Case No. 250071 Address: 846 Main St.

### **Staff Report**

The applicant has submitted an application for Project Approval for work at 846 Main St., a Contributing structure located in the Upper Main Planning Unit in the City of Deadwood.

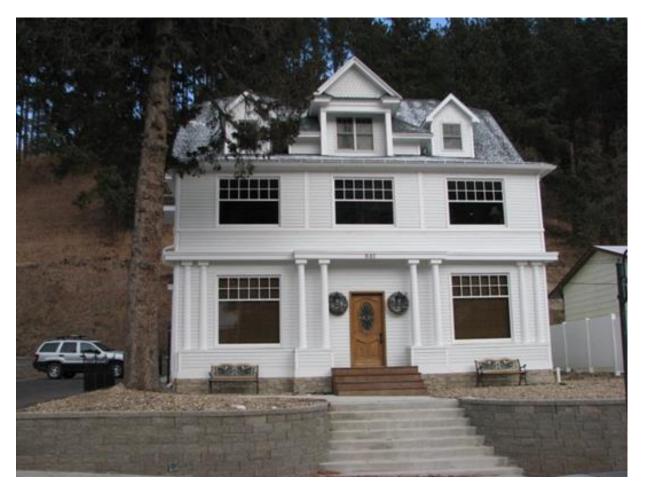
The ownership group is attempting to create a maintenance free exterior of the structure. Wrapping windows can have pros and cons but typically it is not a preservation approach which is acceptable. Without proper sealant, moisture can penetrate the window and rot the window sill without knowledge of the owner. This will require annual inspection and replacement of the sealant on a regular basis, thus not meeting the maintenance free expectations. Additionally, the metal rapping of trim is susceptible to denting from hail. Staff acknowledges some of the trim is wrapped with metal from a previous renovation; however, the sealant seems to have deteriorated and metal slopes back toward the glazing. The wrapping of the windows and facia/soffit with aluminum does not meet the Secretary of Interior standards. Because the proposed work does not meet the standards, it is staff's opinion, the proposed work and changes does damage and destroy the historic materials of the resource and may have an adverse effect on the character of the building or the historic character of the State and National Register Historic Districts or the Deadwood National Historic Landmark District.
